**Kaufland Australia Pty Ltd**

**10 ANZAC Highway Forestville**

090/E004/18 – Deferred item

**OVERVIEW**

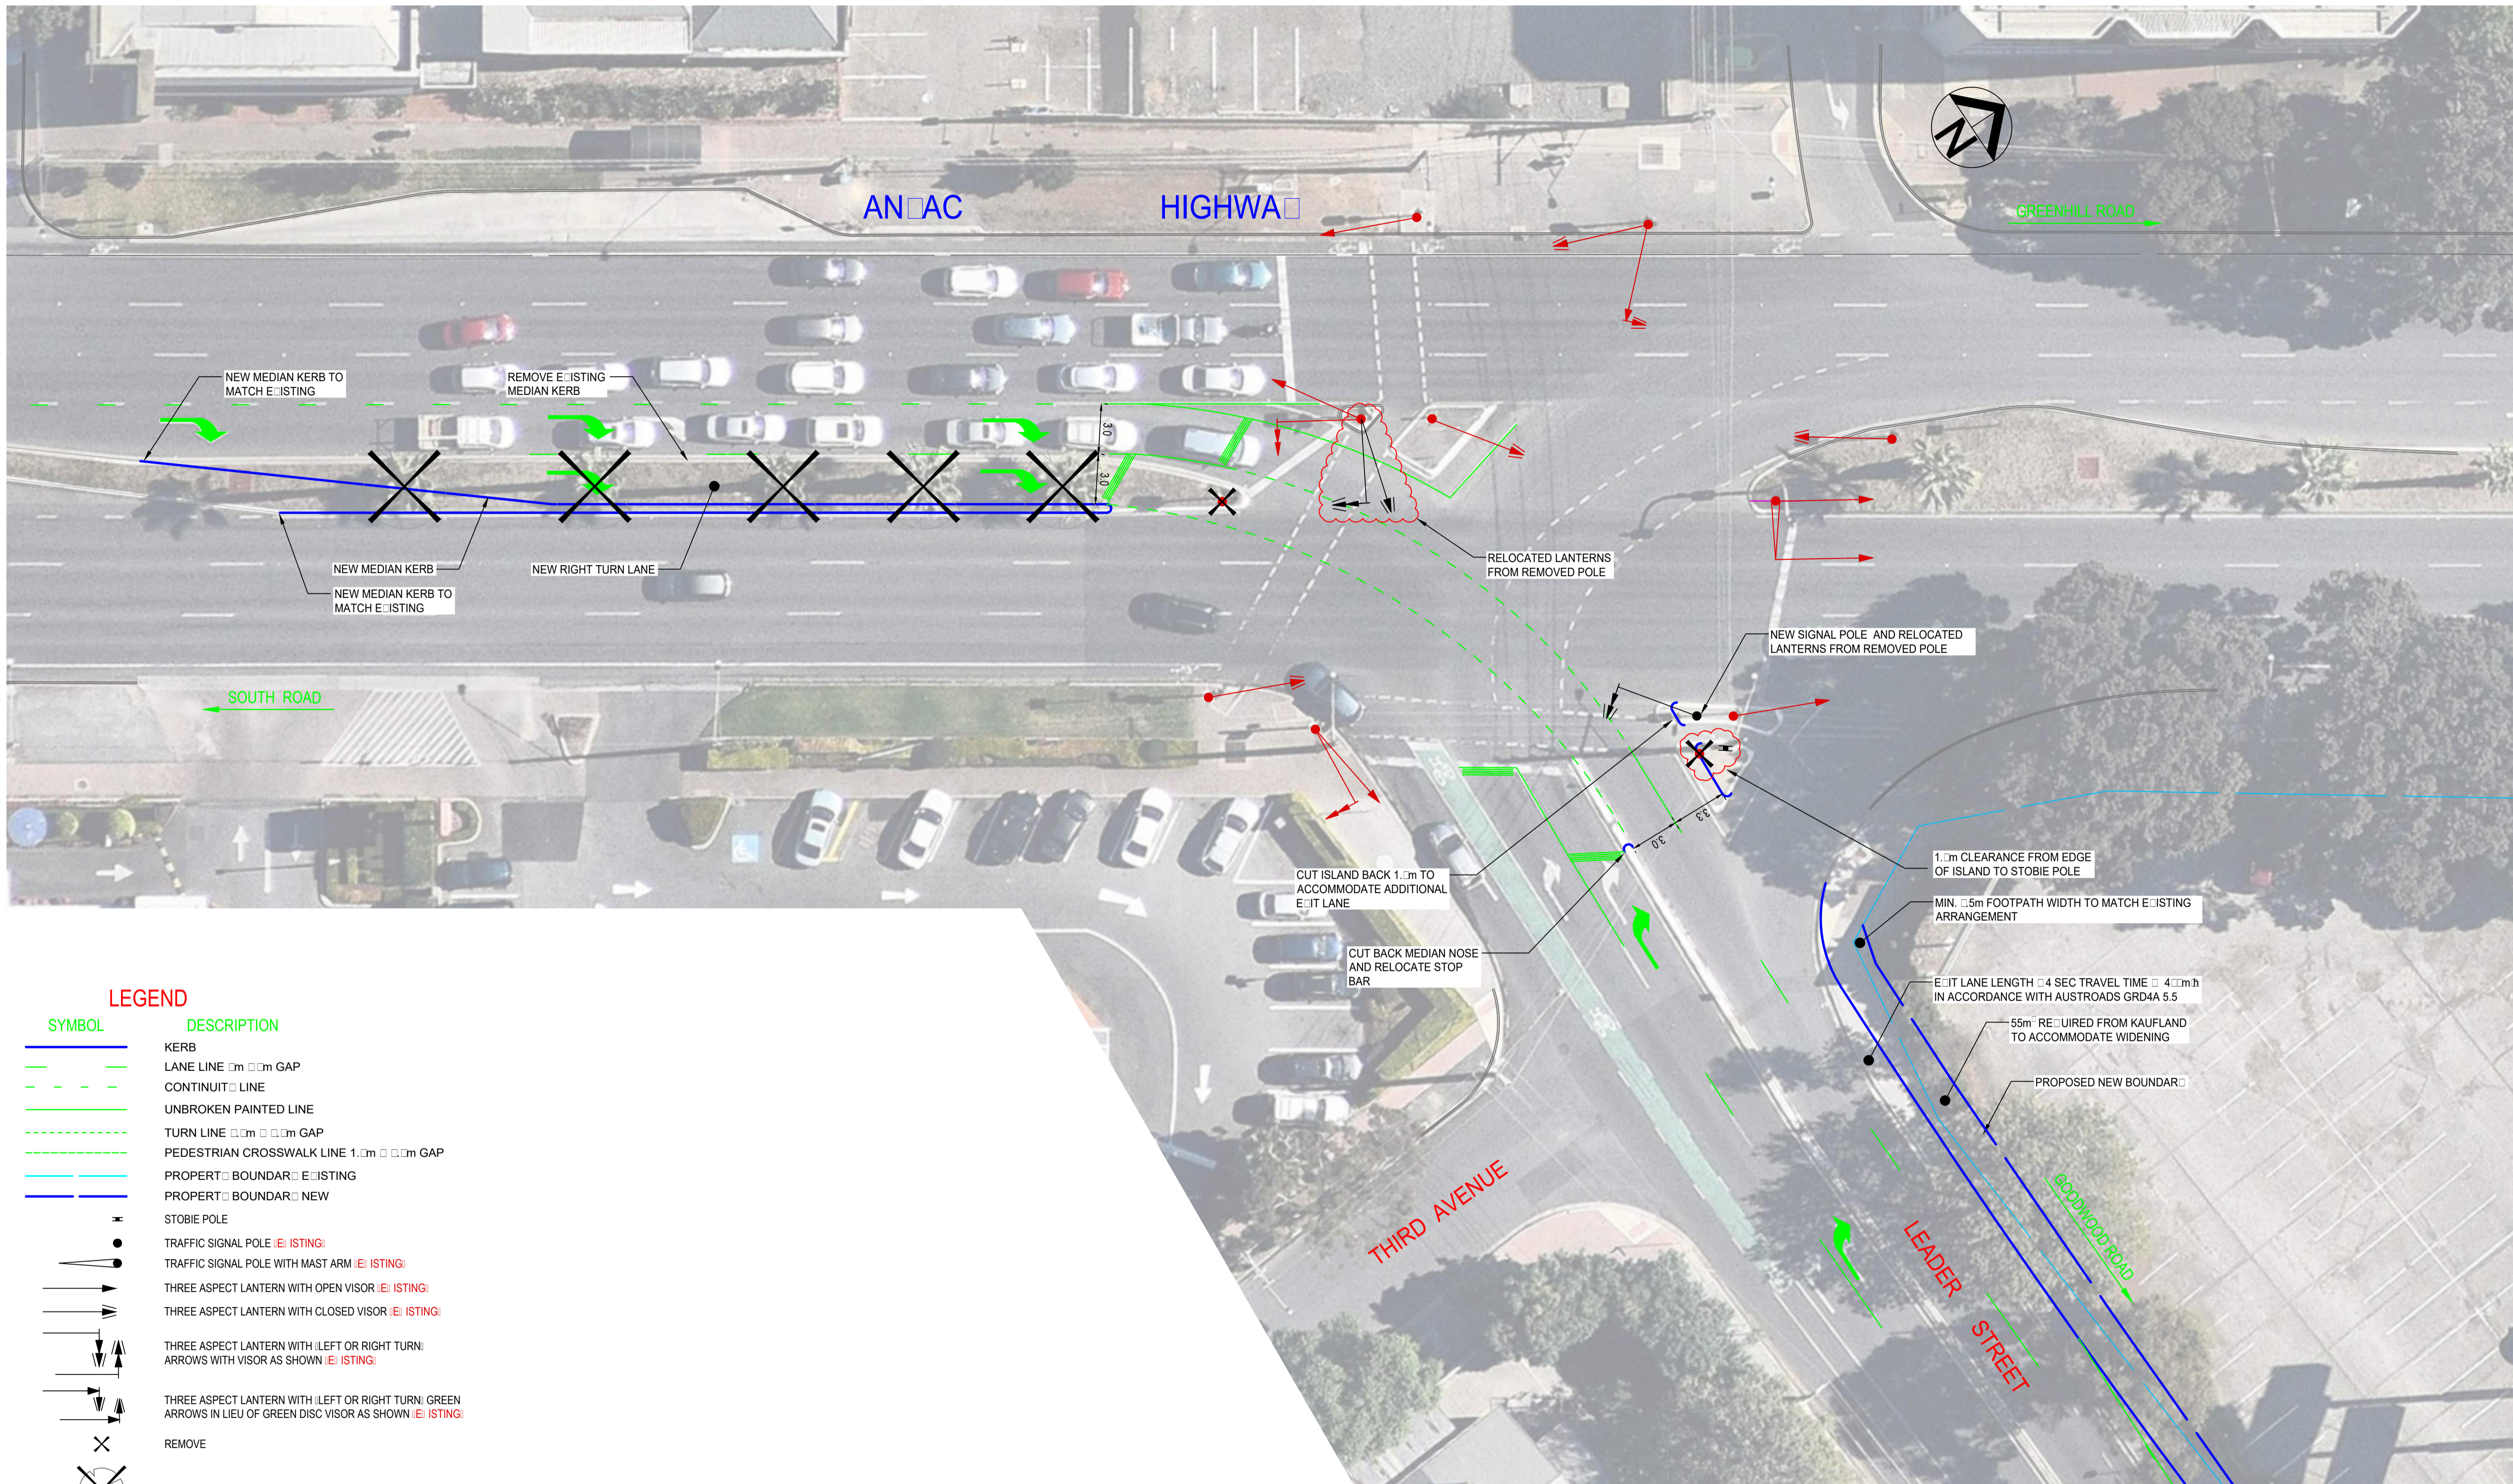
In summary we recommend the attached proposal to ameliorate DPTI's concerns regarding the potential increase in delay imposed by the proposed development.

The attached concept design demonstrates that two right turns can be accommodated by narrowing the median on the southern approach along with some minor signals modifications without relocation of the aforementioned stobie pole.

**Figure 3: Recommended noise barrier location**

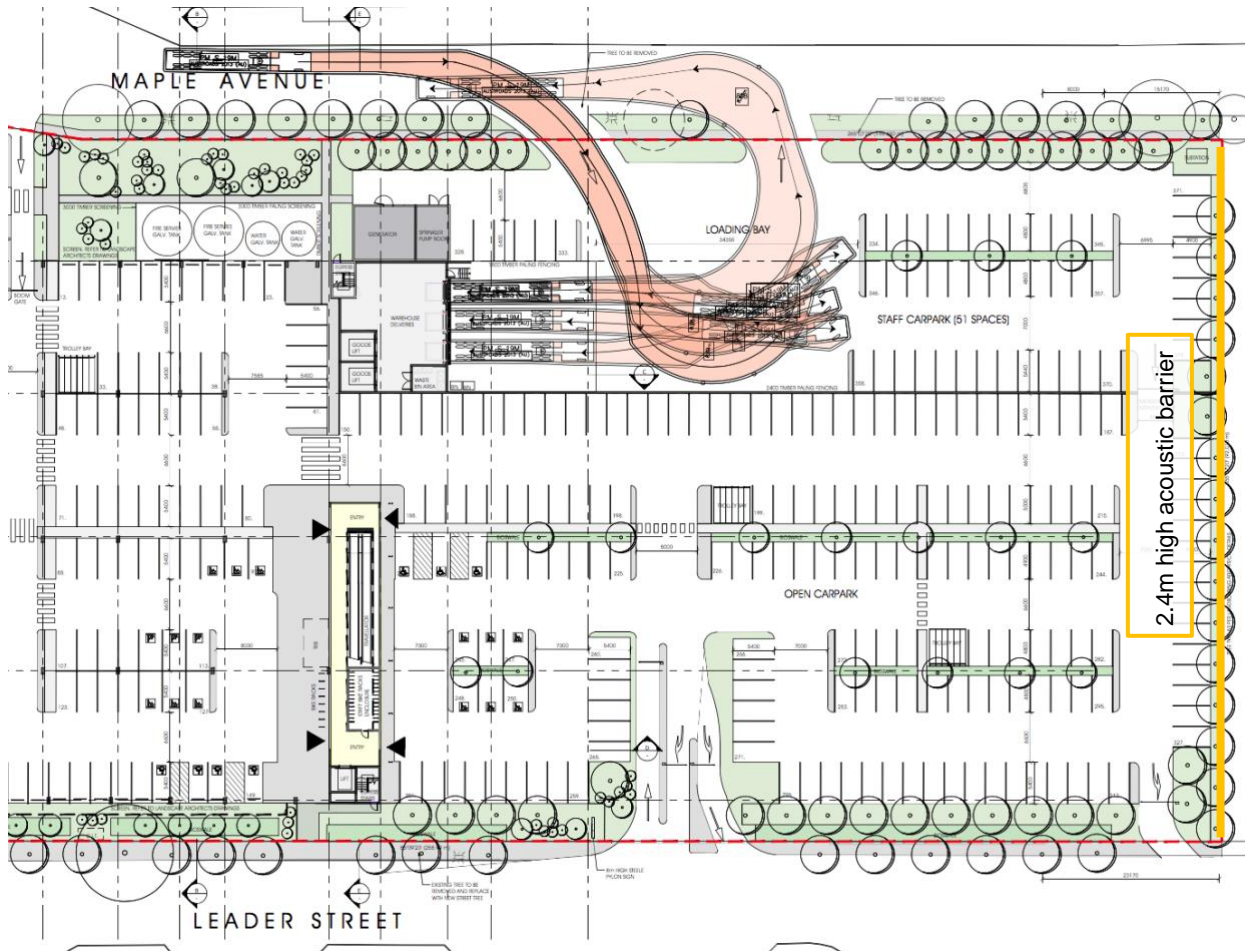
We recommend that a 2.4m high acoustic barrier is constructed in the location shown in Figure 3. The barrier should be minimum 12 kg/m<sup>2</sup> (for example 12mm fibre cement sheet, 19mm plywood, or a double layer of standard colorbond fencing), and constructed without gaps between panels or at the base.

Figure 1: Concept Plan Map Un/11 – from Unley Development Plan

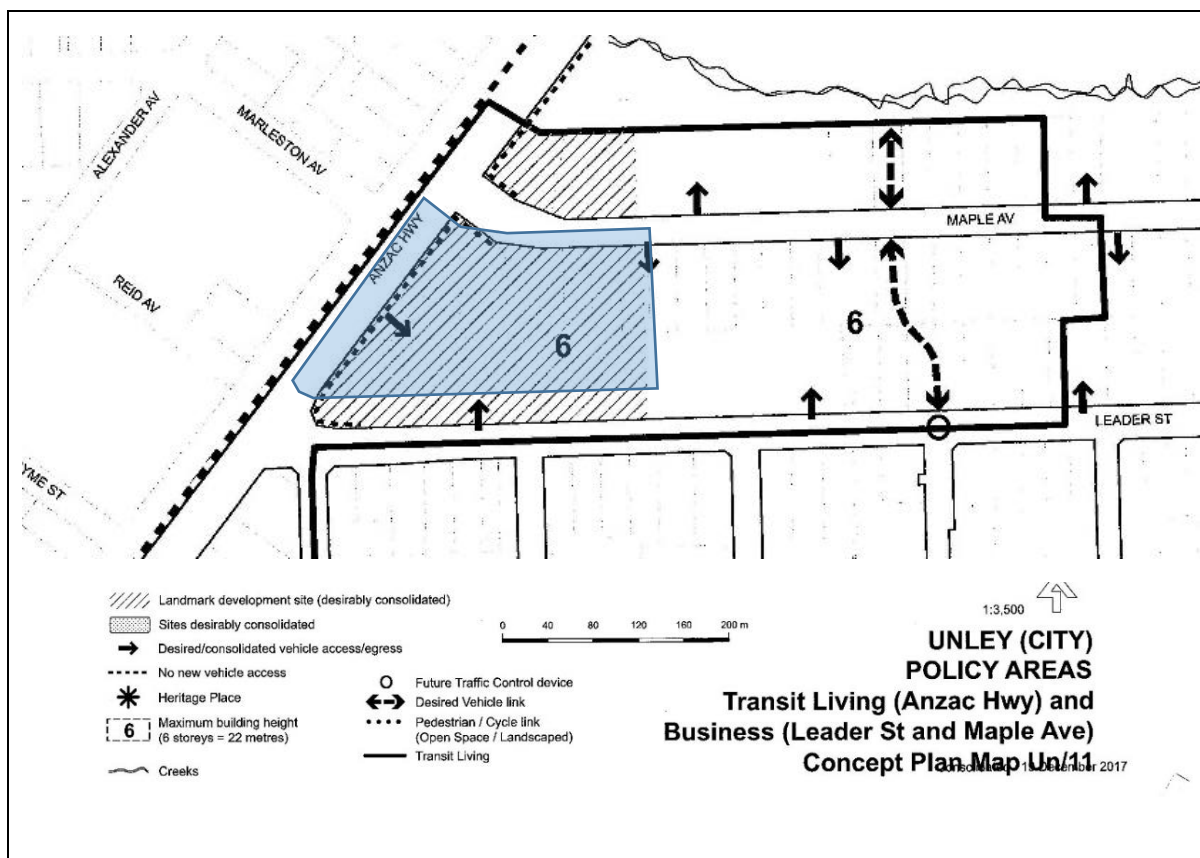
D3	P158	Restricted and consolidated vehicle access points will be available, and access will be mainly from secondary road frontages, limited rear access lanes and through-site integrated and shared rights-of-way.	With reference Figure 1, vehicle access is approximately where shown as desired. <b>Except</b> for the laneway and access points	Resolved
